TECHNICAL EVALUATION REPORT ON THE TENNESSEE VALLEY AUTHORITY'S
PROPOSED METHOD TO CALCULATE ENVIRONMENTAL CONDITIONS
INSIDE CONTAINMENT FOR QUALIFICATION OF SAFETY-RELATED ELECTRICAL
EQUIPMENT DURING A MAIN-STEAM-LINE BREAK

J. N. Edwards
Los Alamos National Laboratory

April 1987

Fig. 1. CVTR containment temperature profiles predicted with average CVTR heat transfer coefficients and bulk temperature with various reevaporization rates compared to maximum measured temperature profile (Ref. 3, Fig. 7).

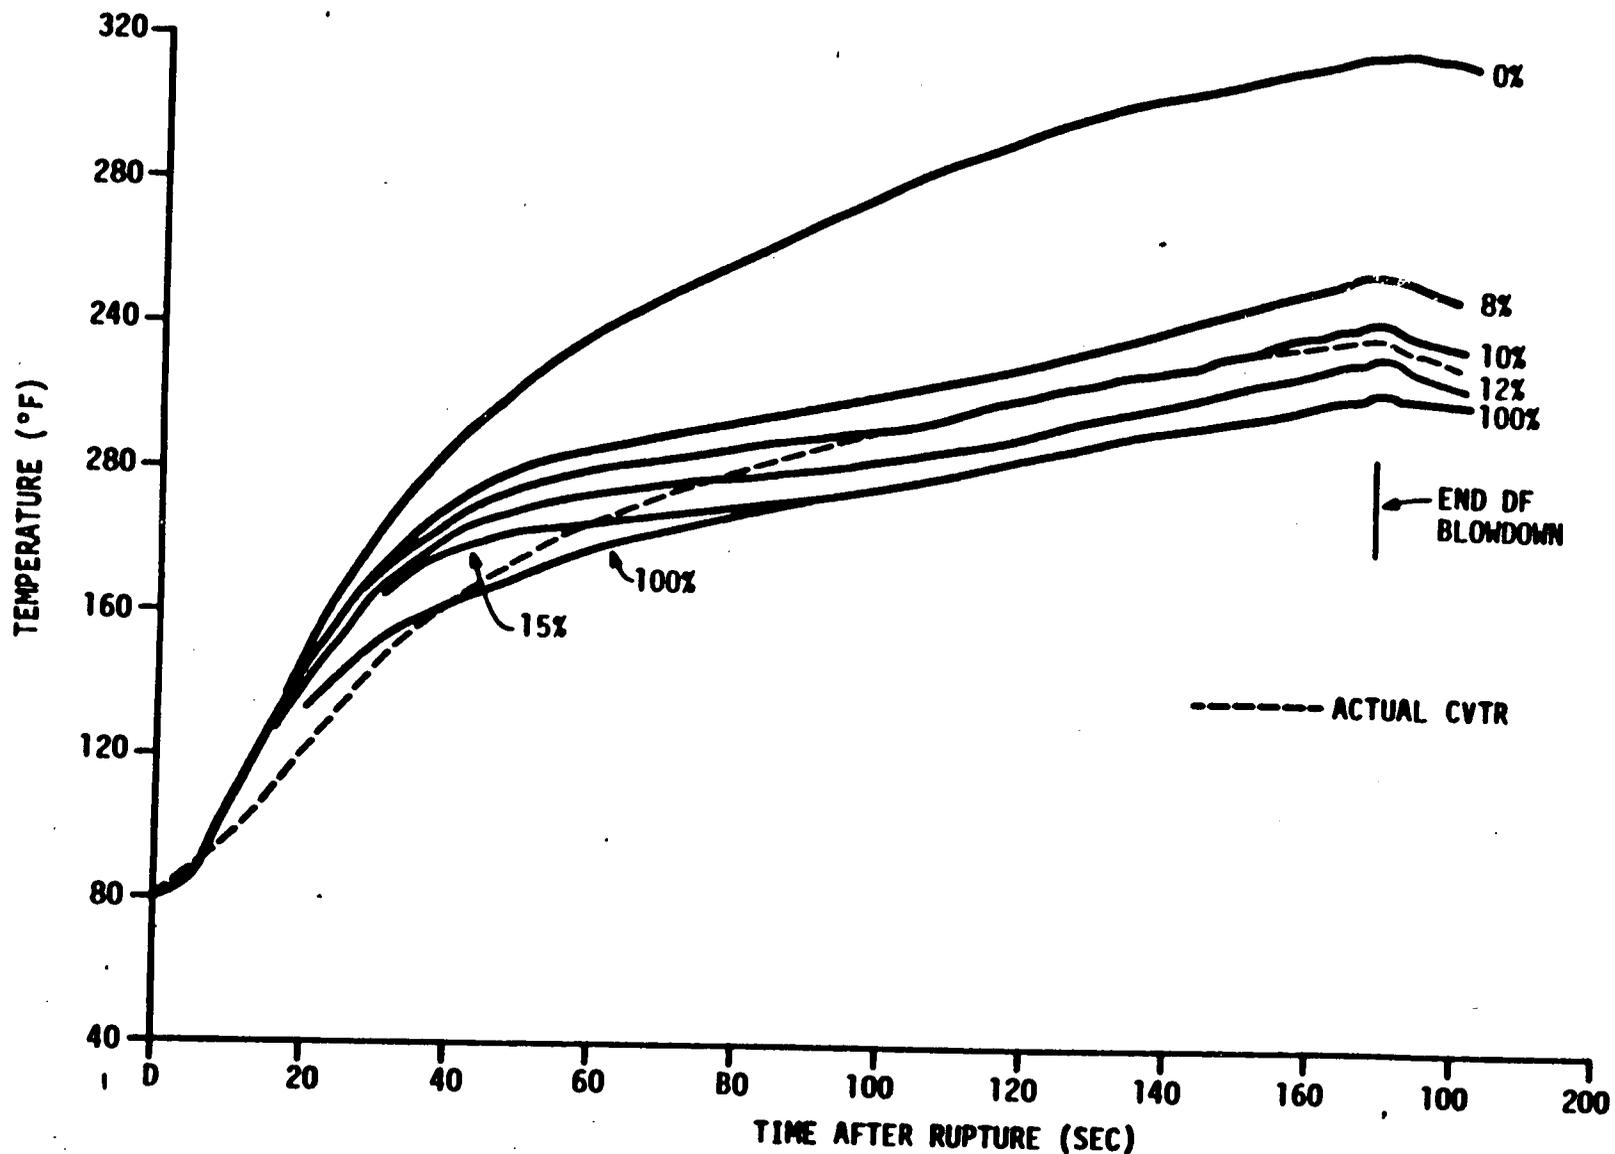
TVA first did a demonstration analysis of the Carolinas Virginia Tube Reactor² (CVTR) containment experiments using their MONSTER containment computer code.³ For its analysis, TVA used the CVTR experimentally determined heat-transfer coefficients and parametrically varied the revaporization rate to achieve a good-fit analysis for the CVTR temperature data (Fig. 1). TVA chose a 10% revaporization rate and considered this analysis conservative because MONSTER over-predicted the maximum CVTR experimental temperature by

4°F. Considering the large spatial temperature variations observed in the CVTR tests (more than 100°F), Los Alamos disagrees with TVA's conclusion that theirs is a conservative analysis of CVTR.

These results demonstrate the conservative nature of the NUREG-0588 method. In Fig. 1, TVA's results of MONSTER calculations for CVTR using the average experimentally observed CVTR heat-transfer coefficients were presented. These heat-transfer coefficients are used with ΔT based on the bulk atmosphere temperature. Results were plotted for various revaporization rates. Based on this figure, TVA proposes that the calculation using 10% revaporization is a conservative evaluation for CVTR. This is an important point in their analysis; however, in looking at Fig. 1, Los Alamos cannot agree. First, based only on the figure, the 10% curve lies right on top of the experimental data for a significant portion of the time and ends up 4°F higher at the peak. This is not a conservative estimate in our opinion, particularly when you consider that a temperature stratification of more than 100°F was observed

Our conclusion is that, in light of the significant unanalyzed nonhomogeneous effects observed in the CVTR experiments and the small margin by which TVA over-predicts the peak CVTR experimental temperature, the TVA analysis of CVTR is not conservative.

Fig. 2. NRC's comparison of various revaporization rates used in modeling the CVTR test data (Ref. 8) (Ref. 5, Fig. 3 and Ref. 3, Fig. 1).

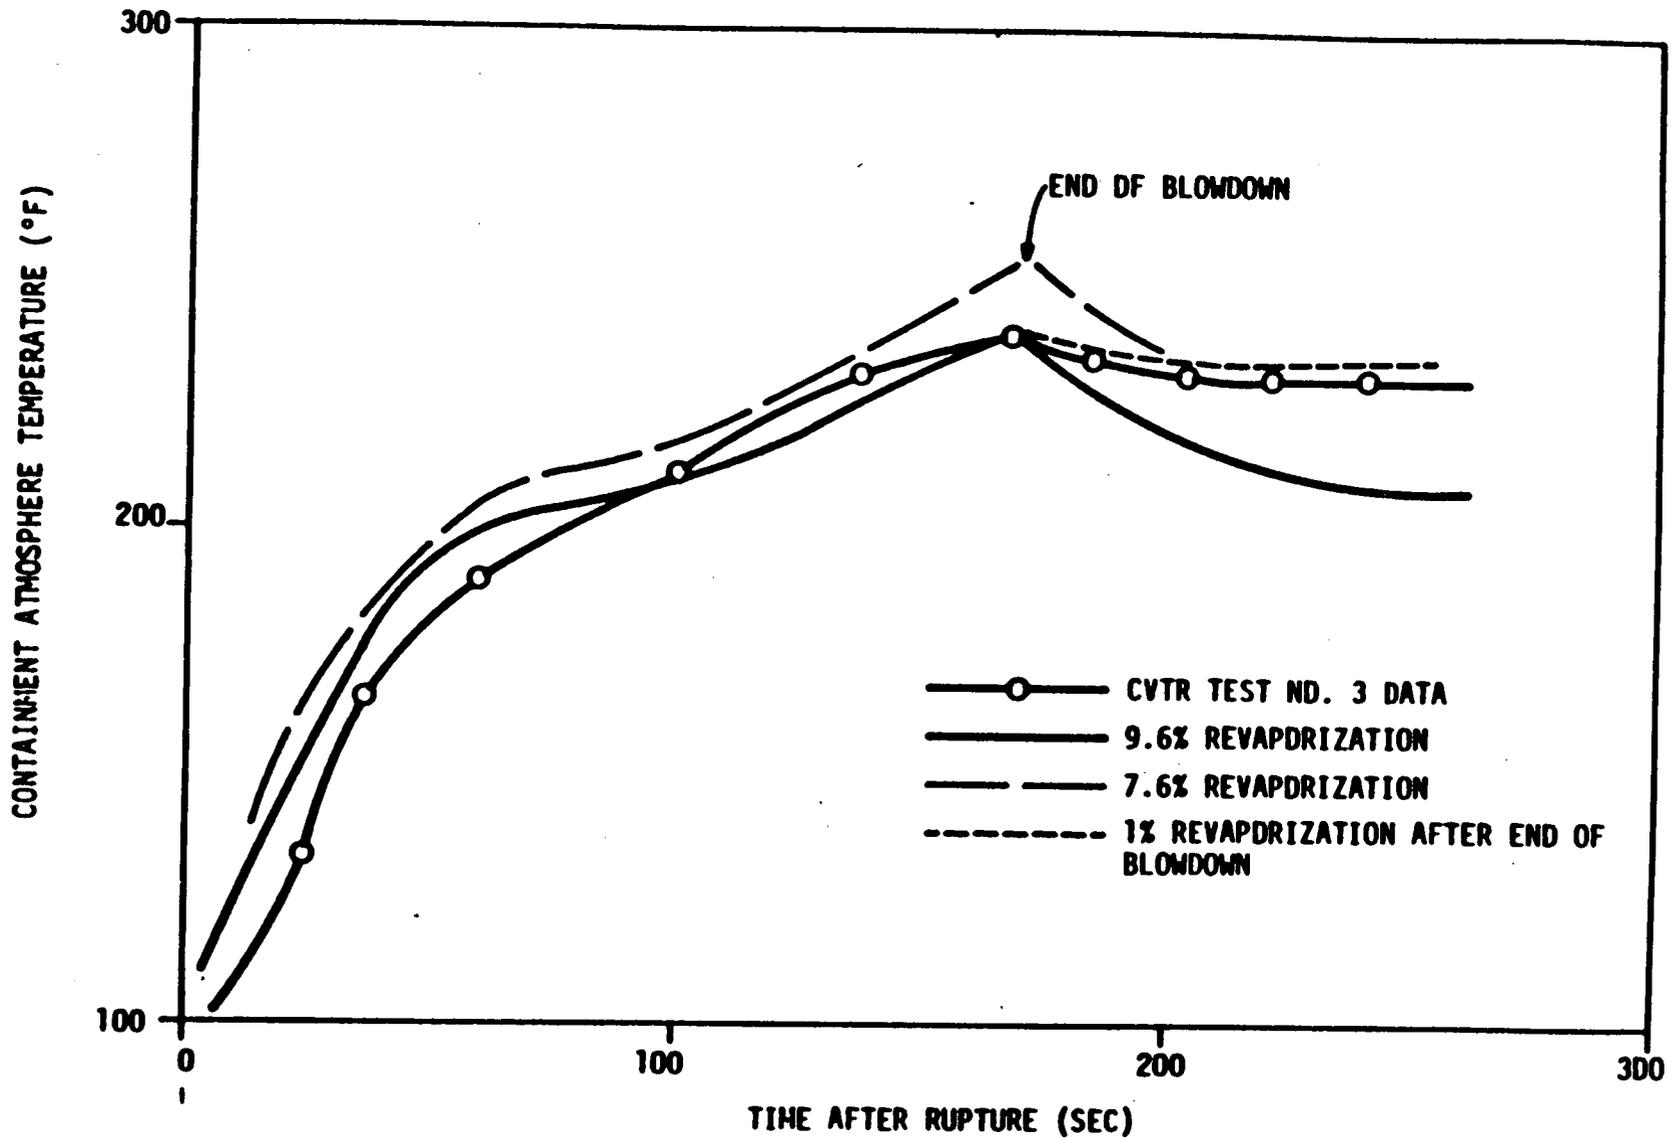
condensate remains in the liquid state in the post-blowdown phase. In Fig. 2 (Tedesco's Fig. 3), the CVTR test results are compared with temperatures predicted using revaporization rates of 9.6% and 7.6%. They note that a revaporization rate of 9.6% gives a best fit to the CVTR data and that 7.6% bounds the CVTR data. A revaporization rate of 7.6% is used for the remainder of the analyses presented in Ref. 5.

We do note that, in looking at all of the other figures in Ref. 5, the heat-transfer coefficient being used (where appropriate) is stated, and in all cases it is the Tagami and/or Uchida correlation. It is easy to see why TVA would have assumed that Tagami and Uchida had been used for Fig. 2.

We have reviewed this issue and conclude that the analysis reported in Ref. 5 (Fig. 2) was done as intended. We believe it was NRC's intention to do a best-estimate calculation for CVTR and determine the best value to use for revaporization rate. For the CVTR data, the actual CVTR heat-transfer coefficients are the best estimate. We acknowledge that it was unfortunate that the heat-transfer coefficient that was used was not reported.

Fig. 3. CVTR containment temperature profiles predicted with Uchida correlation and saturation temperature compared to maximum measured temperature profile (Ref. 3, Fig. 2).

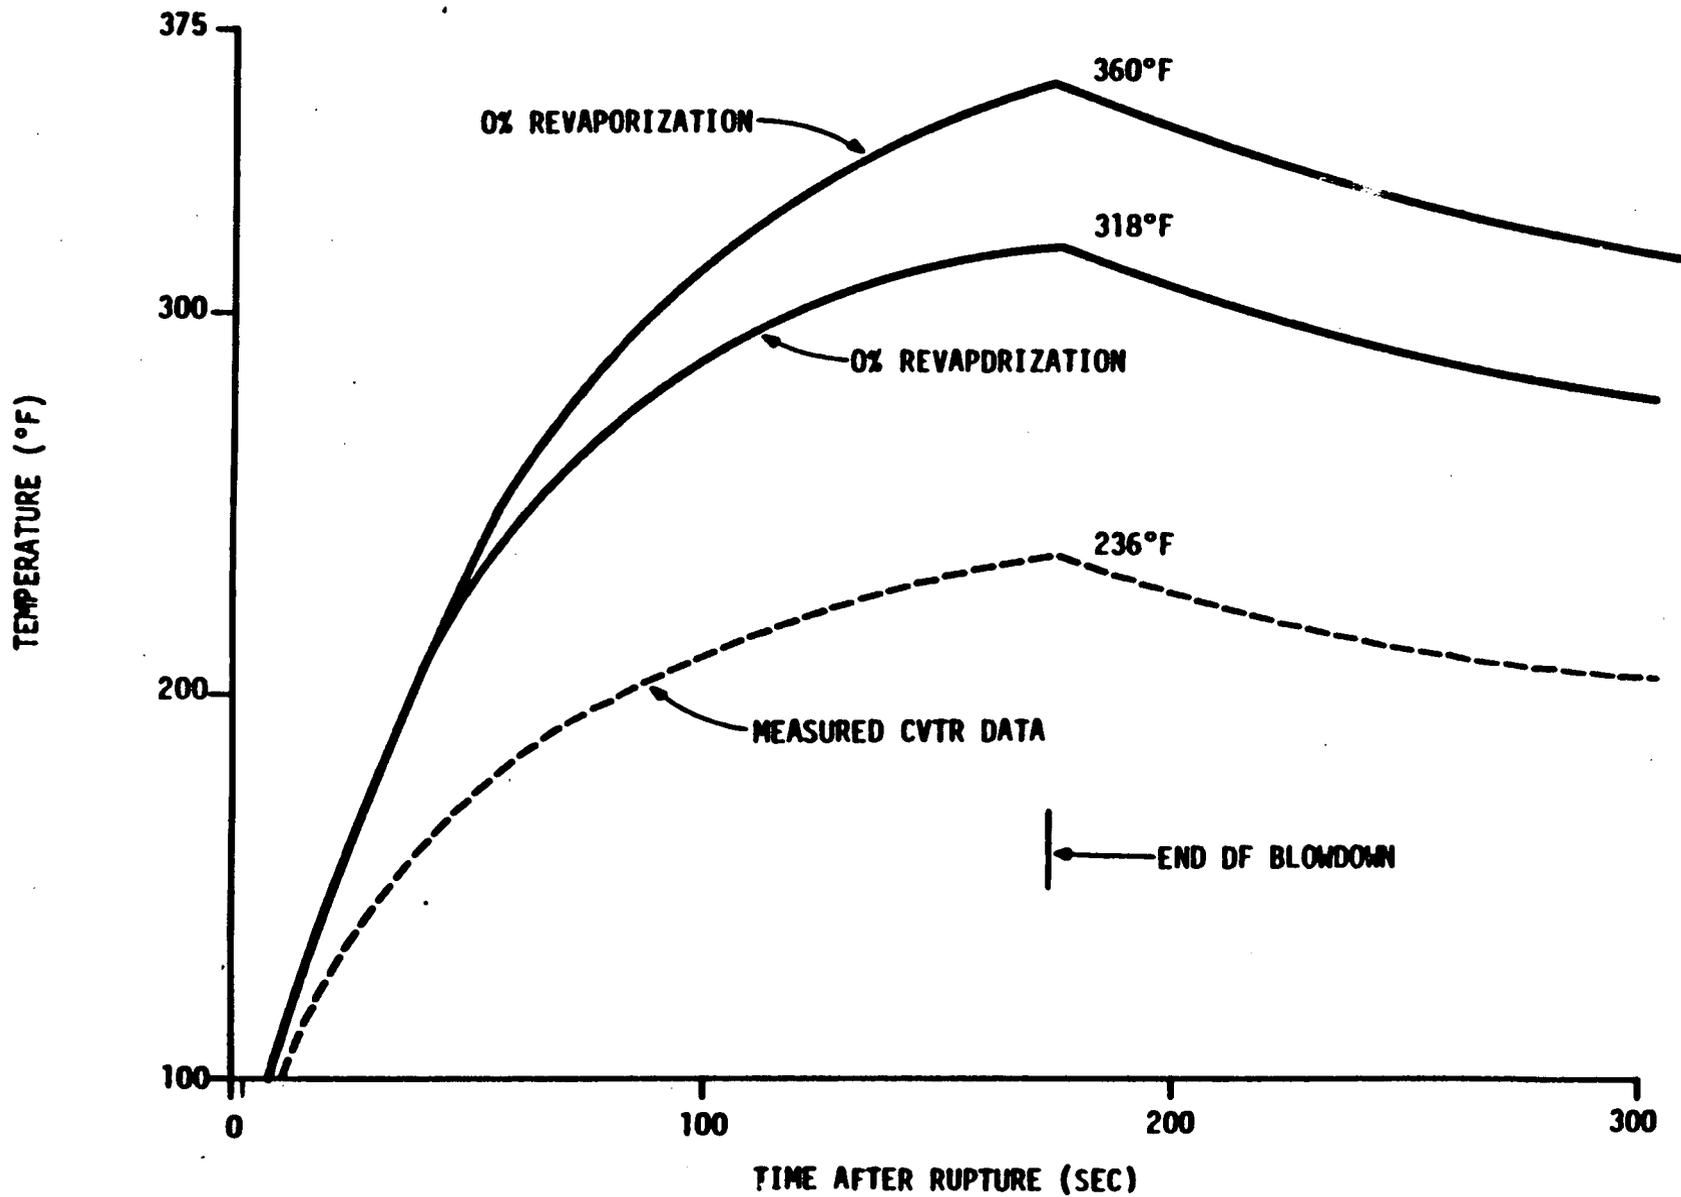
In Fig. 3 (TVA's Fig. 2 from Ref. 3), TVA presents the results of a MONSTER computer code analysis of the CVTR experiments using the NRC NUREG-0588 required methods showing the hottest CVTR experimental temperatures and the temperatures calculated using the Uchida correlation with ΔT based on the saturation temperature and calculated for 0% and 8% revaporization. The peak temperatures are as follows.

CVTR experimental value: 236°F
MONSTER with 8% revaporization: 318°F
MONSTER with 0% revaporization: 360°F

In Sec. II.C.1 of their report,³ TVA compares their method with the NUREG-0588 recommended analysis for the CVTR experiment. Figure 3 shows that TVA calculated a peak temperature for CVTR test 3 of 360°F using 0% revaporization and 318°F using 8% revaporization, as compared with the CVTR experimental value of 236°F. For these calculations TVA used the NUREG-0588 Appendix B method with the Uchida correlation and the temperature difference based on the saturation temperature. TVA compared their results with Fig. 3 of Ref. 5 (our Fig. 2) in which NRC calculated a peak temperature of 250°F using a 7.6% revaporization rate. TVA could not explain the difference between their calculated peak temperature of 318°F and NRC's calculated peak temperature of 250°F for what TVA believed to be identical calculations. Unfortunately, the NRC calculation (Fig. 2) does not state explicitly what heat-transfer coefficients were used. TVA requested that NRC provide additional information, and Los Alamos sent three code input decks to TVA. Upon examining these decks, TVA found that the heat-transfer coefficients used were the actual CVTR values and not the Uchida model that TVA used and that is required by NUREG-0588. TVA raised the question as to whether this was intended or was in error.

Fig. 4. CVTR average heat transfer coefficients measured and scaled for Bellefonte MSLB (Ref. 3, Fig. 10).

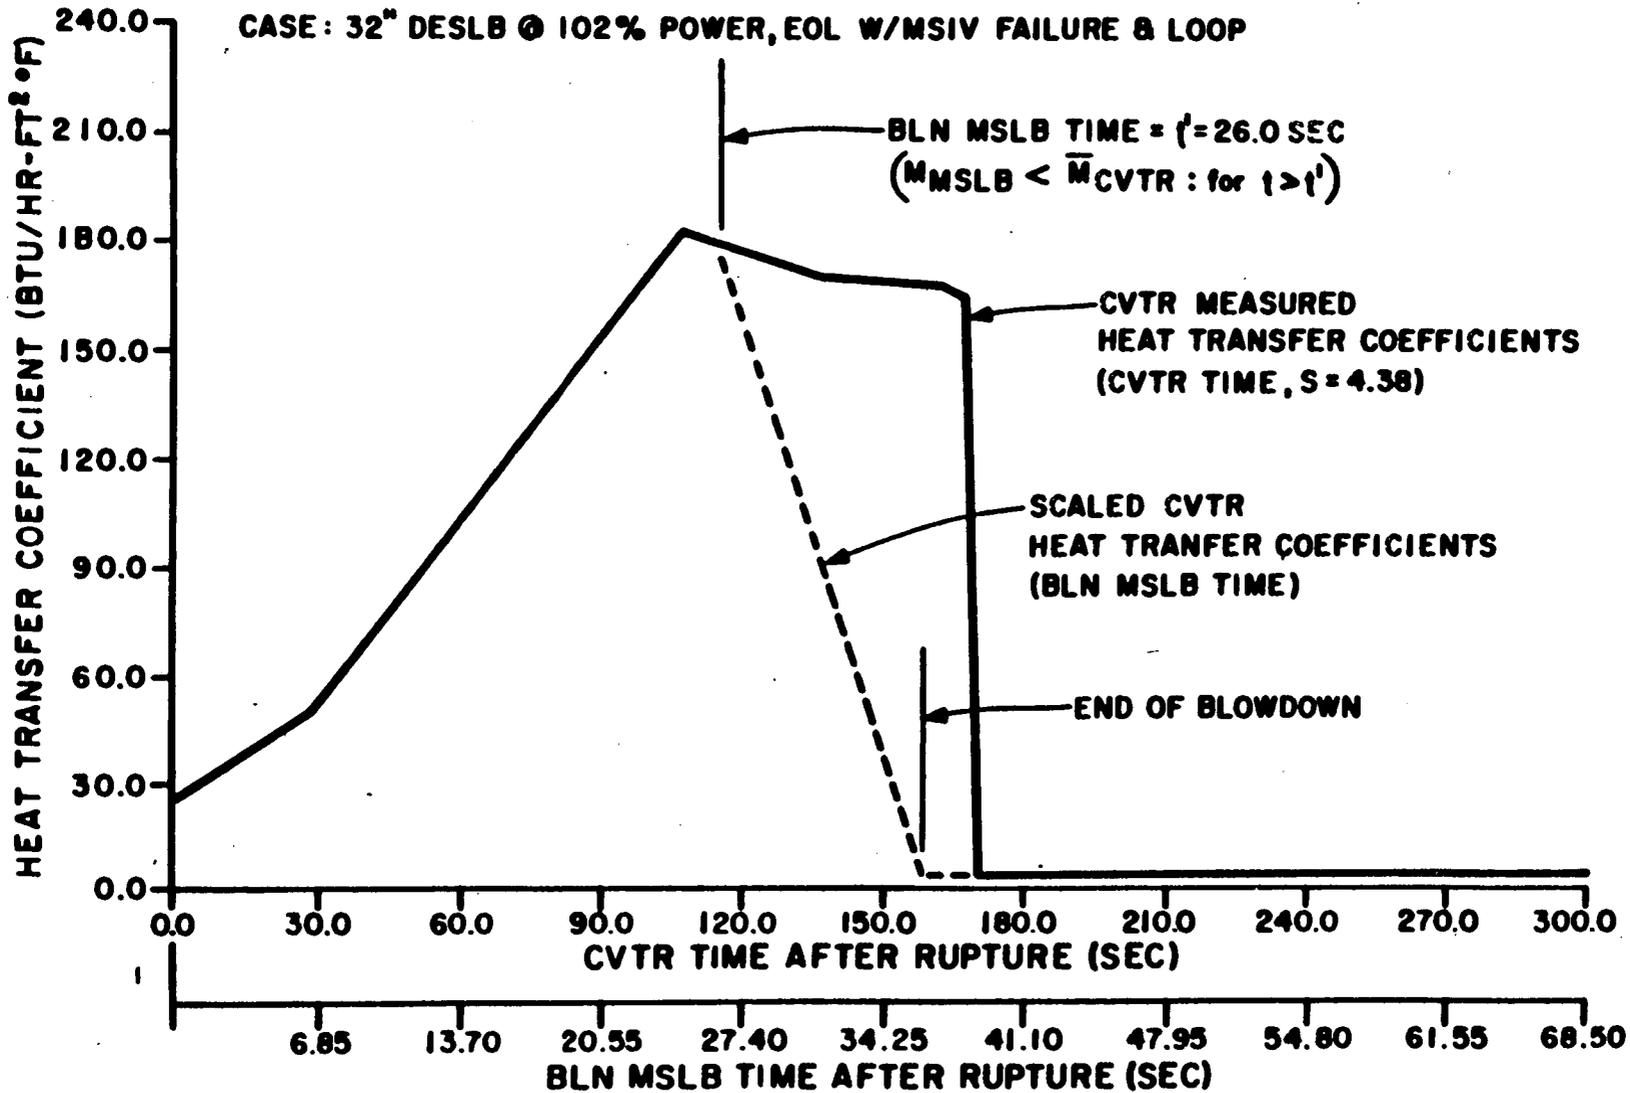
scale by a factor of 4.38 to account for the relative magnitudes of BLN's integrated blowdown rate per unit volume compared with the integrated blowdown rate per unit volume for CVTR. Figure 4 shows the results of this scaling operation. This means that the time of the peak heat-transfer coefficient in BLN is $1/4.38$ of the time of the peak for CVTR. The peak occurs about 110 s for CVTR and 26 s for BLN. Calculatively, this earlier peak heat-transfer coefficient will reduce the peak temperatures calculated for BLN.

The method of scaling that TVA has developed is not supported by any data independent from CVTR nor are the effects on containment temperature calculation evaluated by sensitivity studies.
